Office Action Summary	Application No. 10/597,831	Applicant(s) DE MARTIIS, GIANCARLO
	Examiner MAI T. NGUYEN	Art Unit 3671

DETAILED ACTION

FIG. 1A

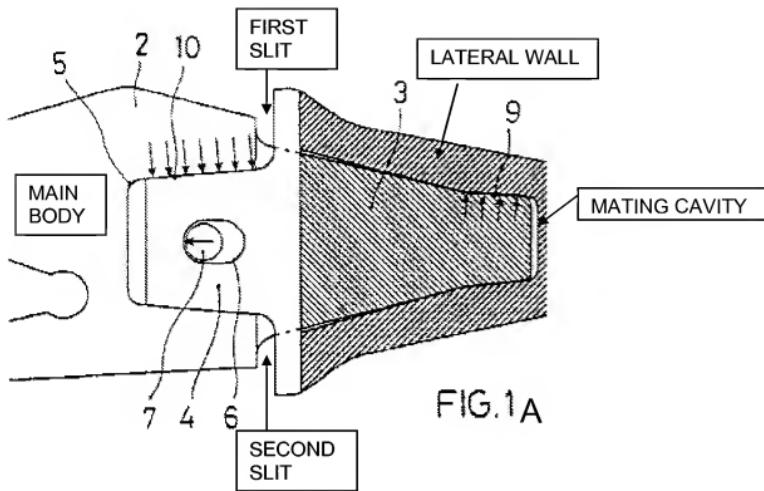
6. Regarding claims 1-3, Vinas Peya discloses a tooth in Figs. 1-13 and Fig. 1A below, comprising a work element 1, 18, a support element 2, 17 having a main body (unnumbered) and a front protrusion 3, 16 inserted in a mating cavity (unnumbered) on a rear of the work element, wherein a pin means 7 inserted in both the support element and work element, wherein the work element comprises appendices 4, 4', 28, 29 arranged symmetrical with respect to a median longitudinal axis, defined by an extension of a lateral wall (unnumbered) of the cavity and able to couple with a mating recess 5, 34, 35 defining an upper edge 12, 13, 32, 33, such that a first slit (unnumbered) is between the upper edge and an upper profile of the appendices, as best seen in Figs. 1, 3 and 7, and wherein a housing seating (unnumbered) for the pin means 7 is made partly in the appendices and partly in the main body, as best seen in Figs. 3, 4, 13, 14.

7. Regarding claim 4, Vinas Peya discloses the cavity is delimited at the lower part by a lower wall (unnumbered), wherein a second slit is between a lower segment of the main body and the lower wall, see Fig. 1A, and is capable of having a greater width than the first slit, as seen in Fig. 8 if a similar force 8 was put on the tooth in the opposite direction.
